6 July 2020

Our Ref: 201015-50004

**ADDENDUM TO MARULAN SOUTH LIMESTONE MINE CONTINUED
OPERATIONS RESPONSE TO DPIE WATER AND NRAR SUBMISSION - DATED 18
FEBRUARY 2020**

Figure 3-2 Marulan Creek Flow Duration Curves for a 30 Year Climate Period

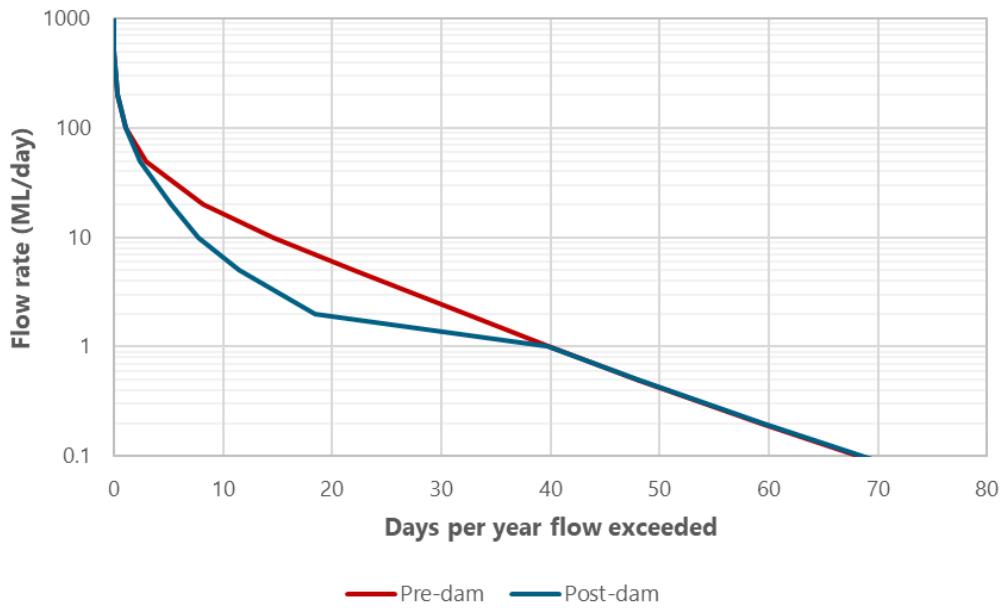
The current flow regime of Marulan Creek was modelled as part of the SWA, with flow duration curves provided in Figure 3-2 (Figure 8.2 of the SWA). Modelling indicates flow only exceeds 0.1 ML/day approximately 70 days per year (20%), with little to no flow the remainder of the year.

The flow duration pre and post construction of the dam was modelled as part of the SWA to assess the change in flow duration. Figure 8.2 from the SWA is reproduced in Figure 3-2. The additional analysis of changes in the mid flow regime was undertaken as part of Advisian’s Response to Submission, as summarised Table 3-3.
